## **Eurovent comments to the Phase 1.1 and 1.2 Draft Reports of Tasks 1, 2 and 3 for the review study on Ventilation Units**

### **Scope: Non-Residential Ventilation Units and Residential Ventilation Units**

**This Position Paper presents comments to the Phase 1.1 and 1.2 Draft Reports of Tasks 1, 2 and 3 for the review study on Ventilation Units published on 25 November 2019. The comments were developed in a joint effort by members of the Eurovent Product Groups ‘Air Handling Units’, ‘Residential Air Handling Units’, ‘Air Filters’ and ‘Energy Recovery Components’.**

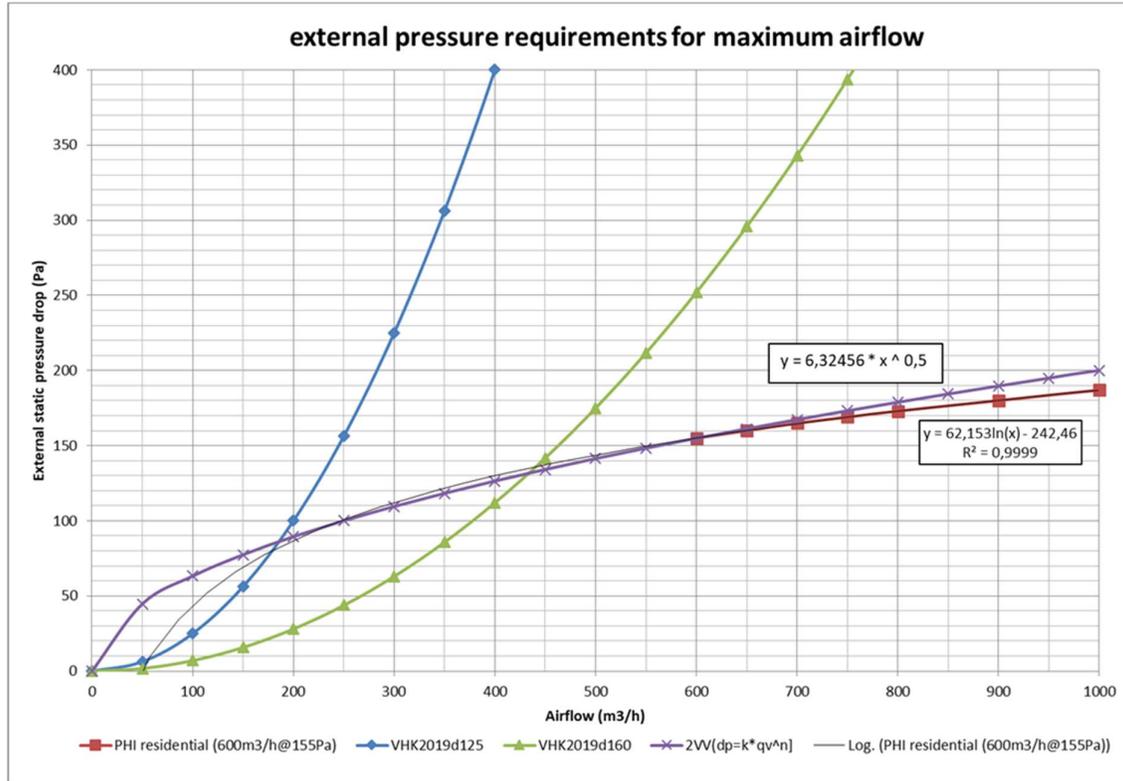
Eurovent supports the principle for adjusting the applicable reference external pressure to the declared maximum flowrate instead of using the fixed value of 50 Pa and to determine the reference flowrate accordingly. We hold it should be a clear distinction between the maximum working point and the reference working point.

**Eurovent is not in favour of relating the external pressure to the cross-section of unit spigots.**

In our opinion, the spigot cross-section is not insufficient to determine the external pressure drop that depends on many other factors. Instead, we suggest using a single function relating the external

pressure to the maximum flowrate. A sample of the function that might be used is presented on the graph below (see purple curve – 2VV,  $\Delta p = 6.32 \cdot q^{0.5}$ ).

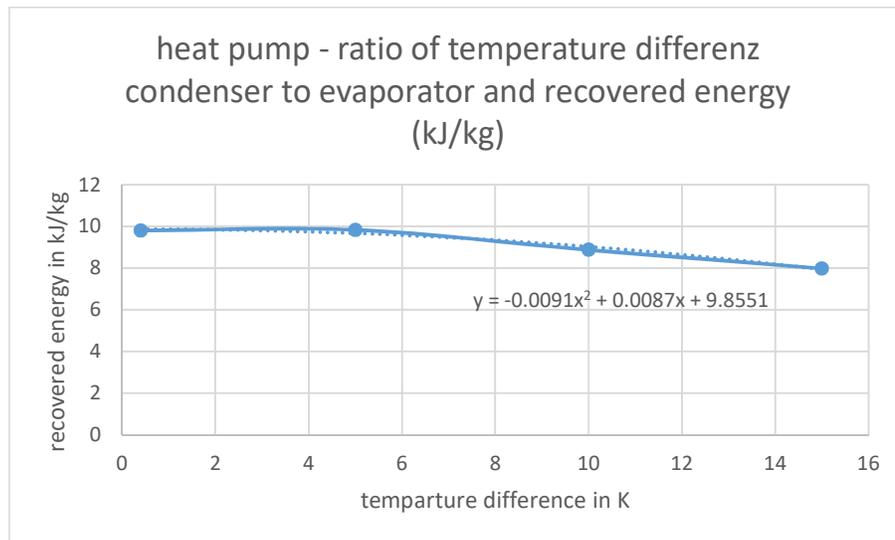
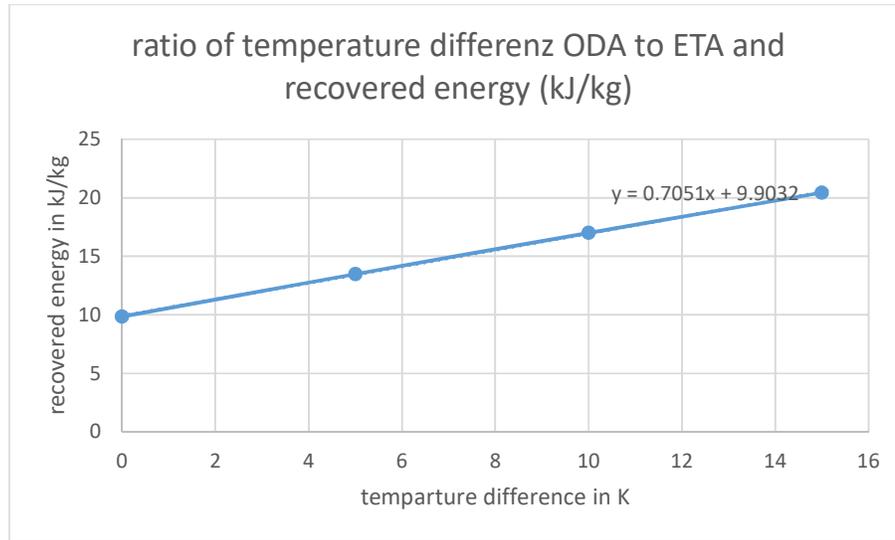
Heat recovery systems, designed with a heat exchanger and an air-to-air heat pump, cannot be valued this way, because they can still recover heat, even when there is no temperature difference between outdoor and extract air. In passive heat exchanger with 73% temperature efficiency is shown in the first graph, displaying the recovered energy in  $\text{kJ/kg}$  over the dry temperature difference.

The next graph shows the results of a heat pump. The heat pump loses efficiency, as the temperature difference between air in of condenser and evaporator increases.

The two systems combined as one heat recovery system then show the following behaviour.

To compare a standard HRS with this combined HRS, we can now use the specific recovered heat energy of both systems. To do so, it is essential to agree on an average temperature difference throughout a whole year in Europe. We believe, that a difference between 10 to 15K represents the average climate situation. Therefore, the ongoing explanation continues with 15K as the extreme of this temperature range. With 15K, a standard HRS with an efficiency of 73% can recover 10.95 kJ heat energy per kilogram dry air. This recovery value shall be the new limit for the minimum heat recovery capacity of an HR + heat pump system.
